Rezoning Application: PD 25-0308

Development Services Department

1.0 APPLICATION SUMMARY

9.0 FULL TRANSPORTATION REPORT (see following pages)

- 1. Site Plan (Revised)
- 2. Transportation Technical Manual TS-4 Exhibit
- 3. Typical Section Curb and Gutter
- 4. Proposed Typical Section

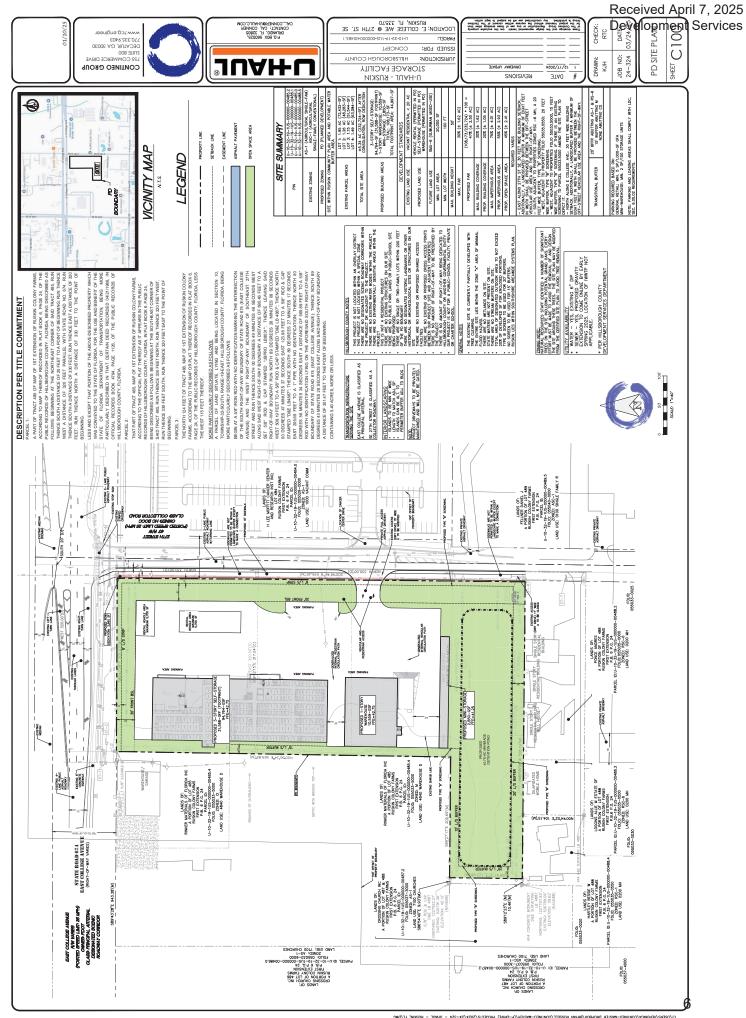
- 1. Provide a 24" curb and gutter along the west side of SE 27th Street. The limits of improvement are 696 feet of curb and 699 feet of gutter.
- 2. Provide a 10-foot wide multi-use sidewalk along the west side of SE 27th Street. The total length of this improvement is 655 feet.
- 3. Dedication of approximately 2,660 SF of right-of-way. The ROW dedication width varies in range between 2 and 6 feet.

- 1) TS-4 has 64 feet of right-of-way. The right-of-way along the property frontage is approximately 71 feet. ROW is not substandard.
- 2) TS-4 has sidewalks along both sides of SE 27th Street. There is no current sidewalk along the road frontage for the proposed U-Haul Development. The revised plan calls for a 10-foot wide sidewalk.

I have found the attached Design Exception (DE) for PD 25-0308 APPROVABLE.
